CITY OF ALBUQUERQUE

**RE: Suazo Residence Lot 8 Block 10 Unit 22 Volcano Cliffs
6511 Petirrojo NW
Grading and Drainage Plan
Engineers Stamp Date 1/15/16 (D10D0003P8)**

ENGINEER'S SEAL	LOT 8, BLOCK 10, UNIT 18 VOLCANO CLIFFS SUBDIVISION	DRAWN BY JDG
	GRADING AND DRAINAGE PLAN	DATE 01-14-2015
		SHEET # 1 OF 1
1/15/16		JOB #
DAVID SOULE P.E. #14522	1606 CENTRAL AVENUE SE SUITE 201 ALBUQUERQUE, NM 87106 (505) 872-0999

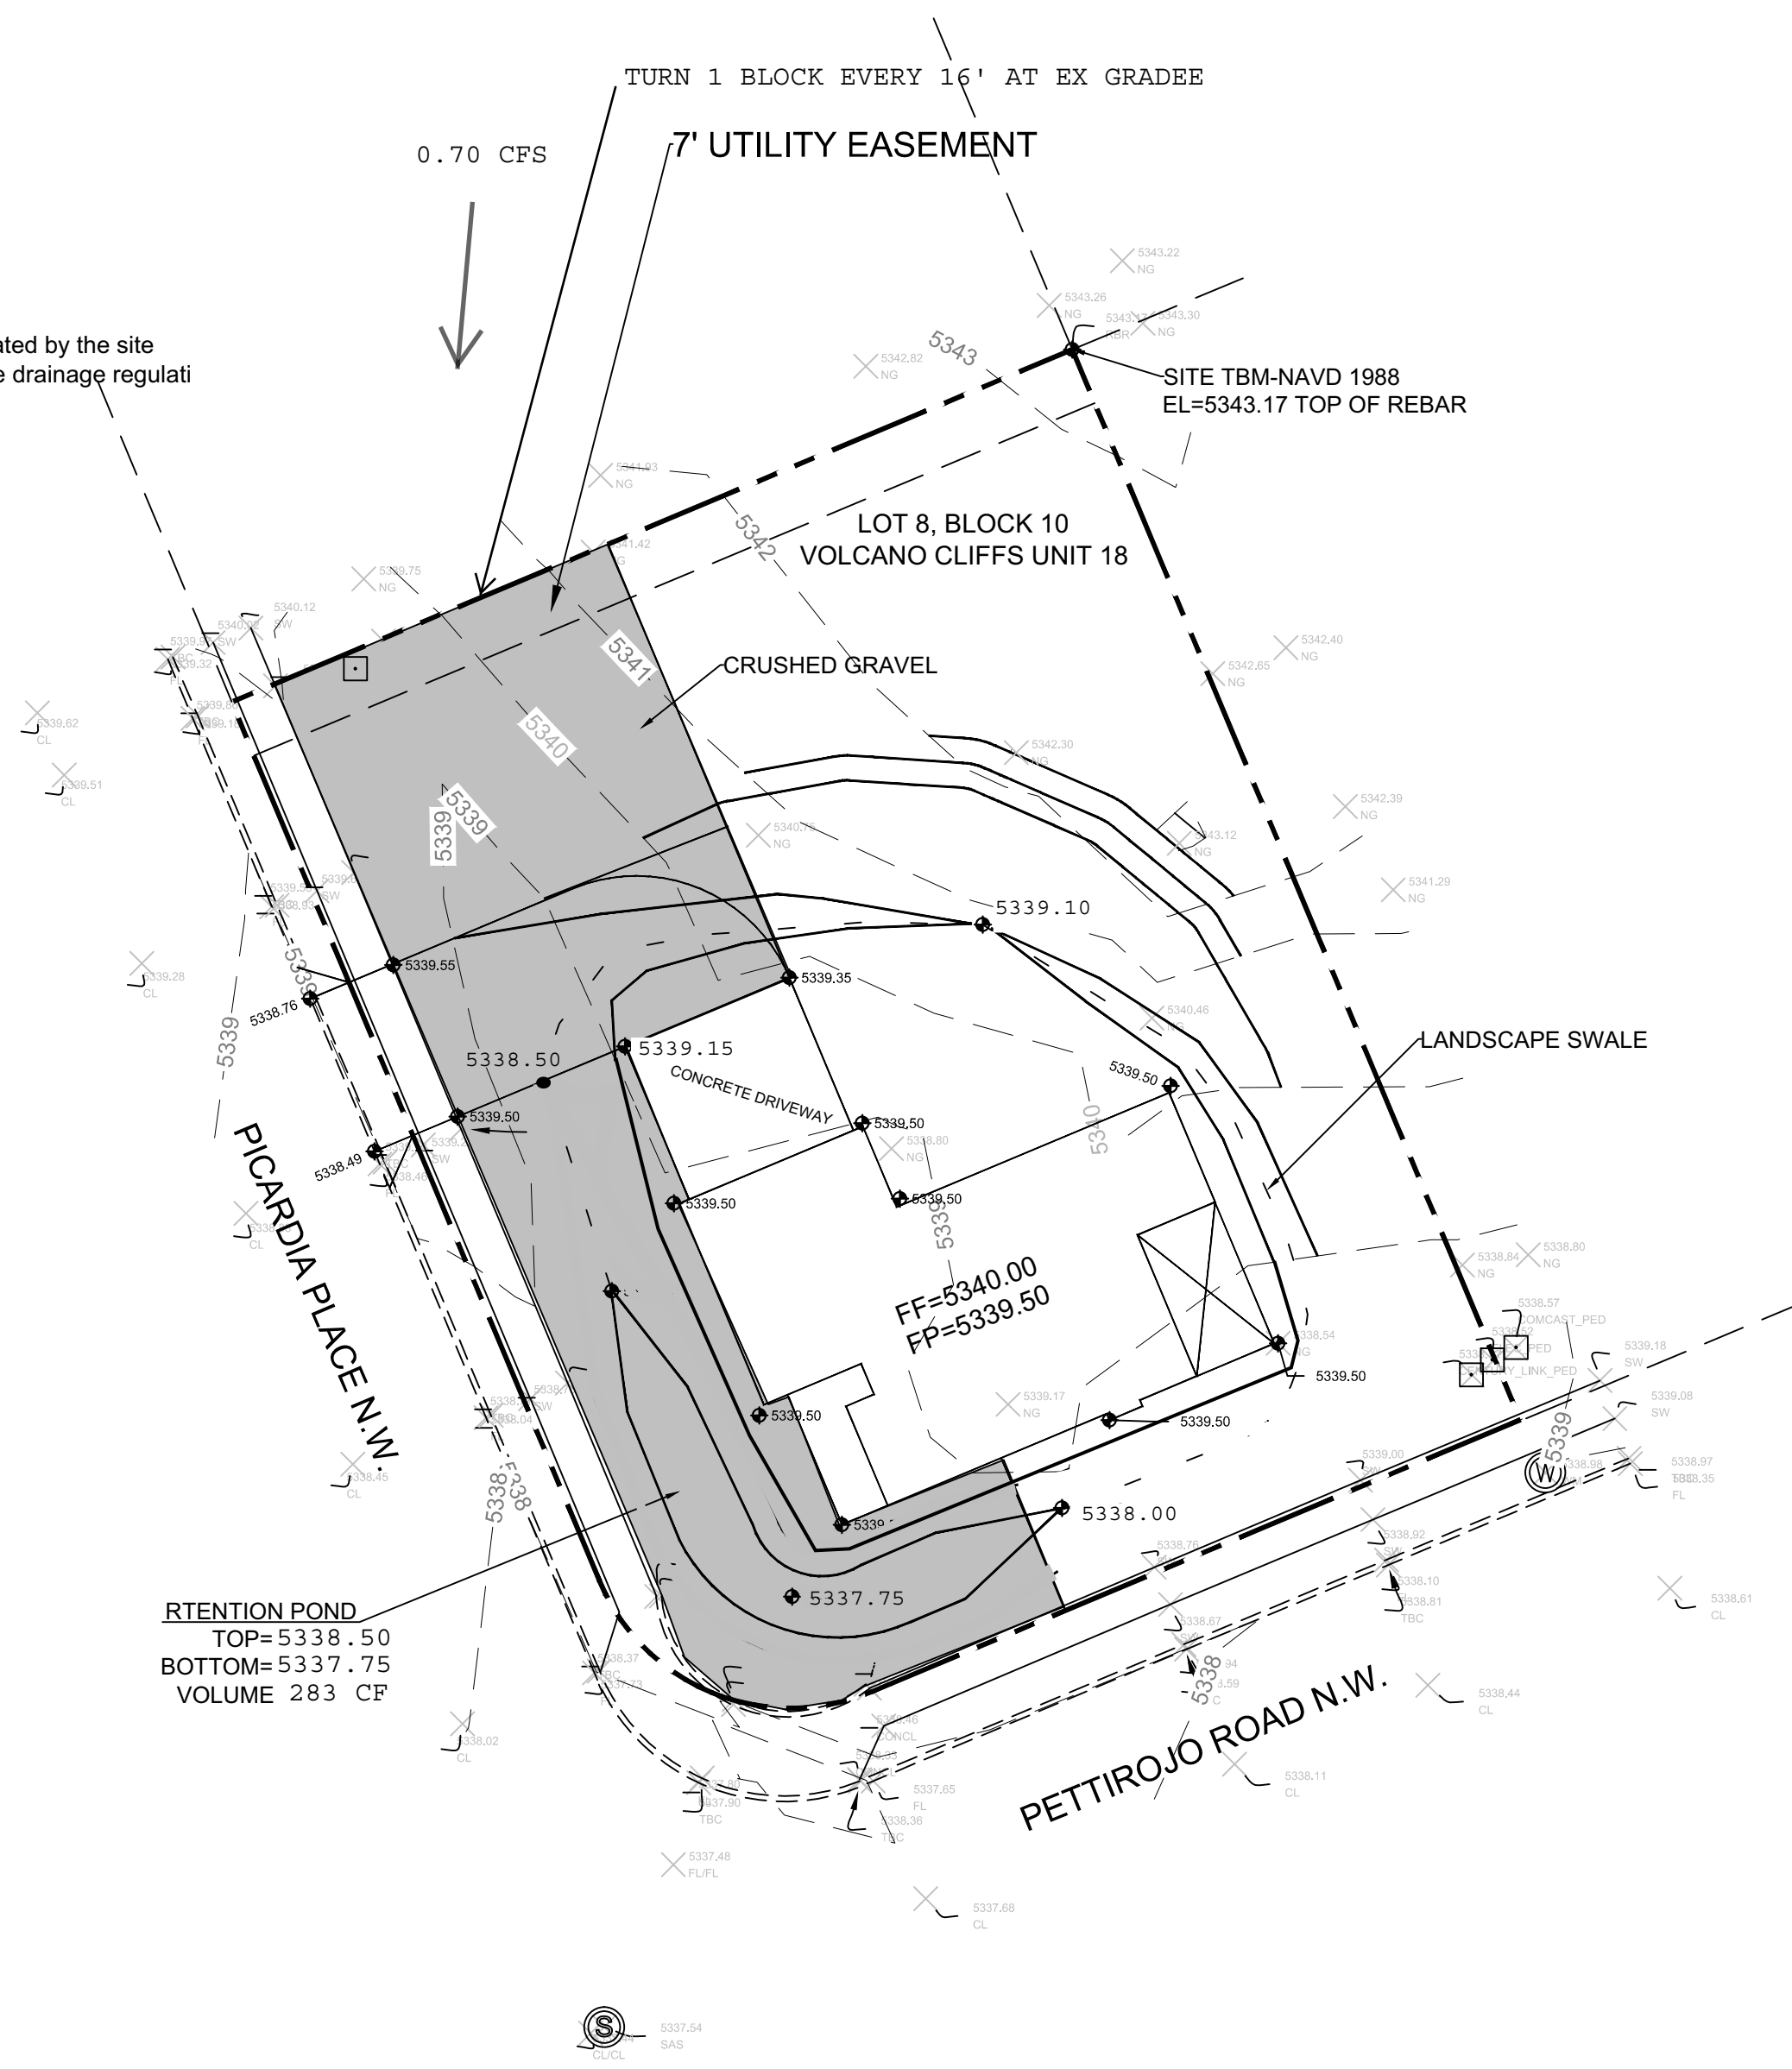
- Provide turn blocks in the east and west rear yard walls to allow flows to pass through and into the double sidewalk culvert in Picardia Place.
